REGIONAL REVIEW FINDING

ARC REVIEW CODE: R603021

Submitting Local Government: City of Atlanta
Name of Proposal: 1163 West Peachtree

Preliminary Report:	March 2, 2006	DEVELOPMENT OF REGIONAL IMPACT REVIEW REPORT	Project:	1163 W Peachtree Street #1054
Final Report Due:	March 31, 2006		Comments Due By:	March 16, 2006

V/C Ratios

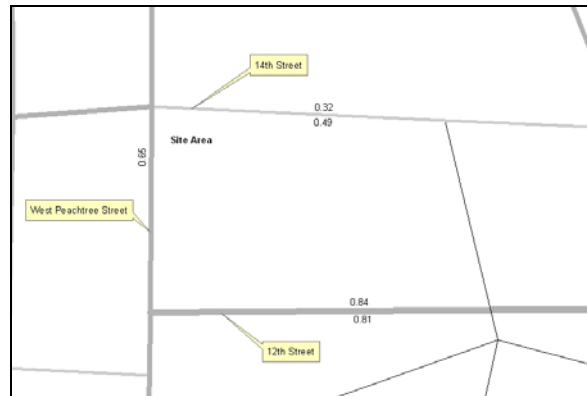
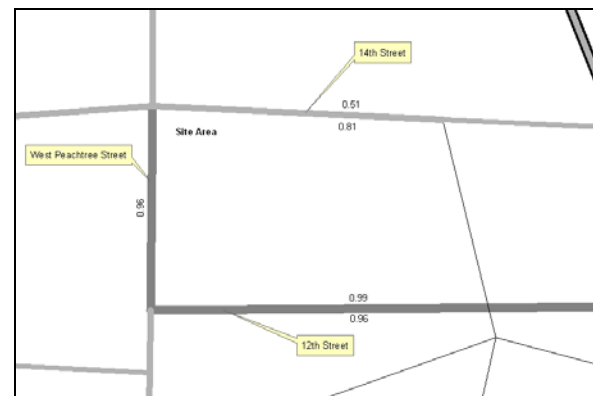
For the V/C ratio graphic, the data is based on 2005, 2010 and 2030 A.M./P.M. peak volume data generated from ARC's travel demand model for Mobility 2030, the 2030 RTP and the FY 2005-2010 TIP, approved in December 2004. The travel demand model incorporates lane addition improvements and updates to the network as appropriate. As the life of the RTP progresses, volume and/or V/C ratio data may appear inconsistent due to (1) effect of implementation of nearby new or expanded facilities or (2) impact of socio-economic data on facility types.
